APPLICATION FOR DRIVEWAY CUTS AND OPENINGS

CITY OF CAMBRIDGE

Address of proposed curb cut or off-street parking facility: 65 Jay Street

Re: Curb cut permit application

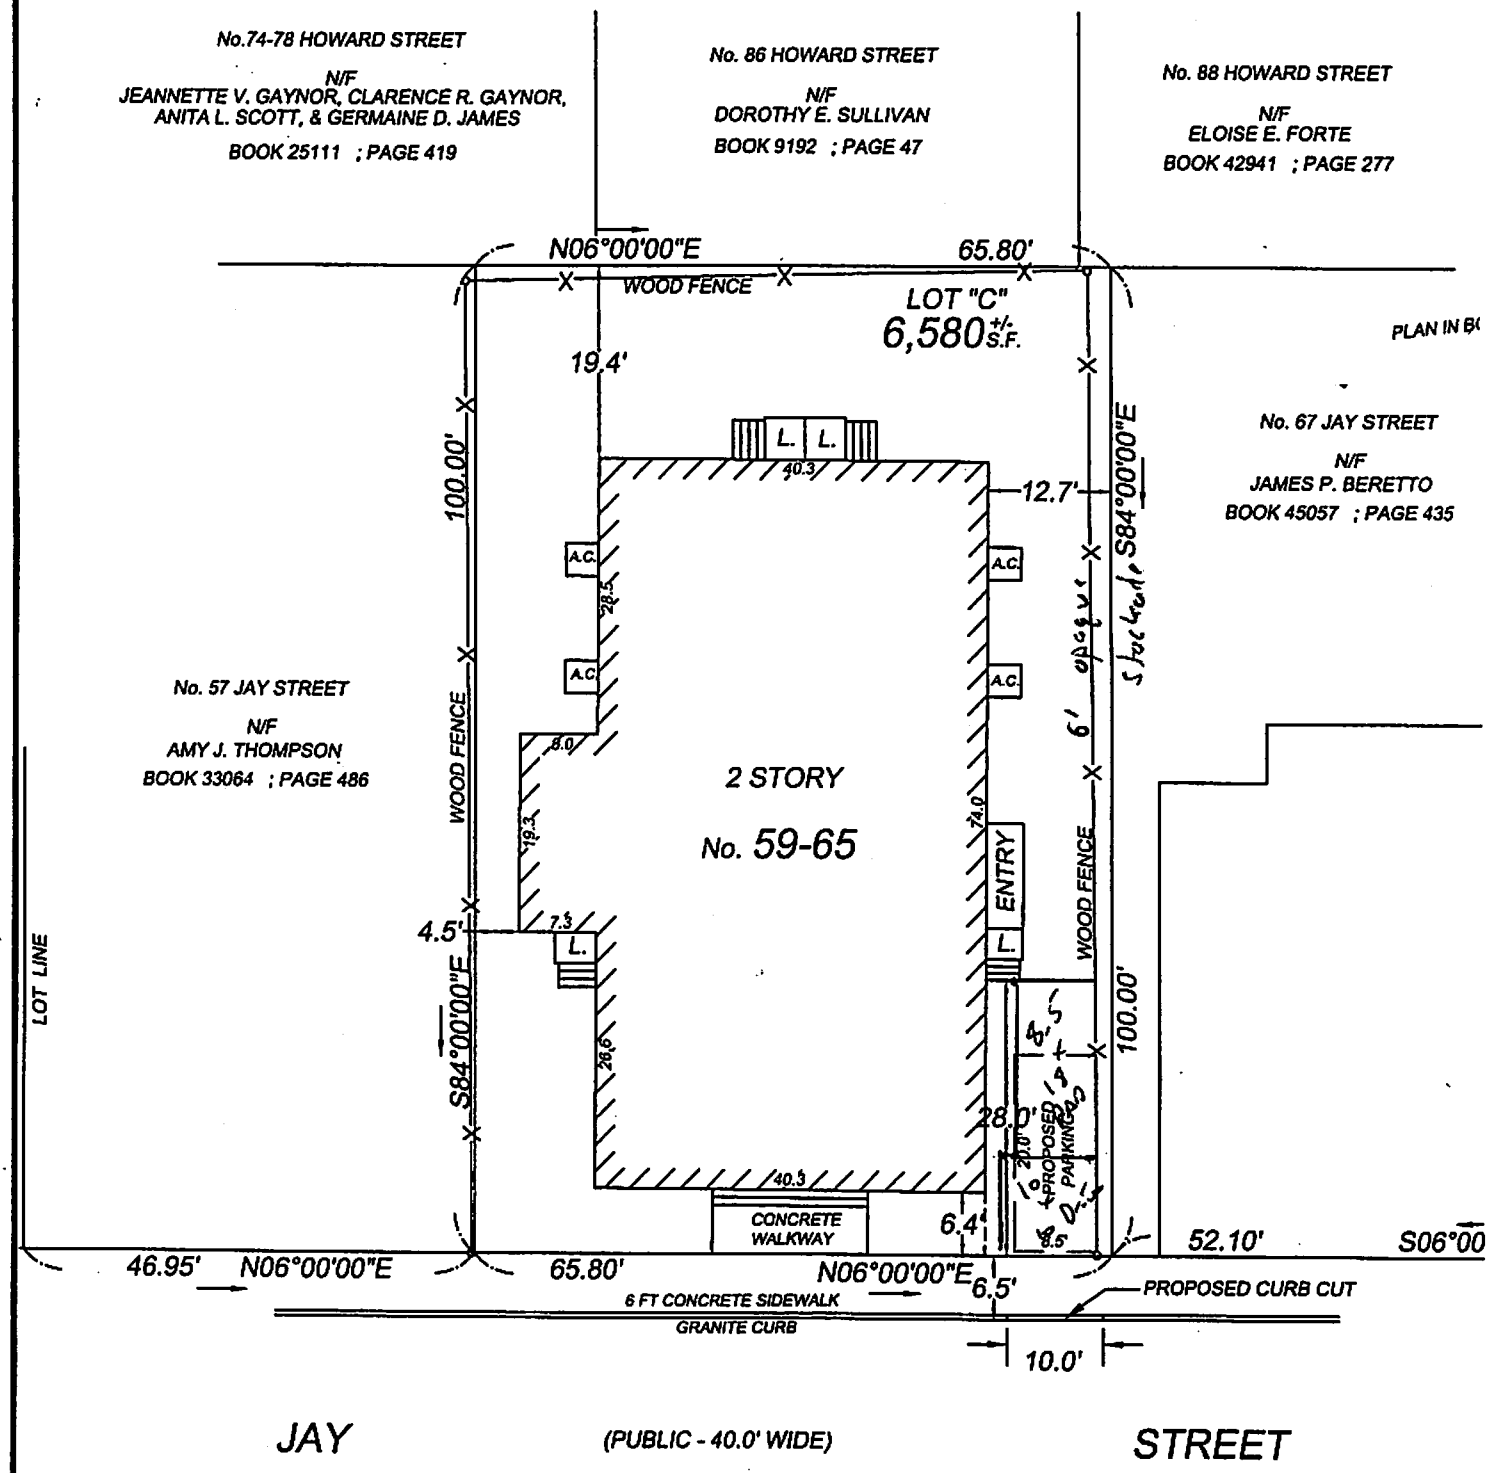
I have received your curb cut permit application for 65 Jay Street. I am writing to inform you that I am unable to approve your application with the driveway in its proposed location. It is important for the safety of pedestrians on the sidewalk that there are no visual obstructions around the perimeter of the driveway. On your property I found a 6-foot stockade fence on the north side of the driveway along the entire property line. The fence would prevent a driver backing out the driveway to see people walking by on the sidewalk from the north.

If you want to place the driveway in the location shown on your application, you would need to alter the fence. I recommend you contact me so that we can discuss your options.

As we discussed by telephone yesterday, you agreed to alter the opaque stockade fence on the north side of the driveway. The objective is to form an unobstructed sight line from the driver's eye (assuming the car is backing out of the driveway) to a point 10 feet down the sidewalk from the northern edge of the driveway. There are several ways to accomplish that, but a common approach is to leave a section of the fence three feet above the ground open at the edge of the sidewalk.

I agreed to approve the permit contingent on making this alteration.

2. You make arrangements to address the section of fence/ correct the site lines for all pedestrians [Remove 6' high section and replace with tapered 3' section] This work will also be a condition on the excavation permit that your contractor will be required to obtain from my office prior to beginning construction on the curb cut.
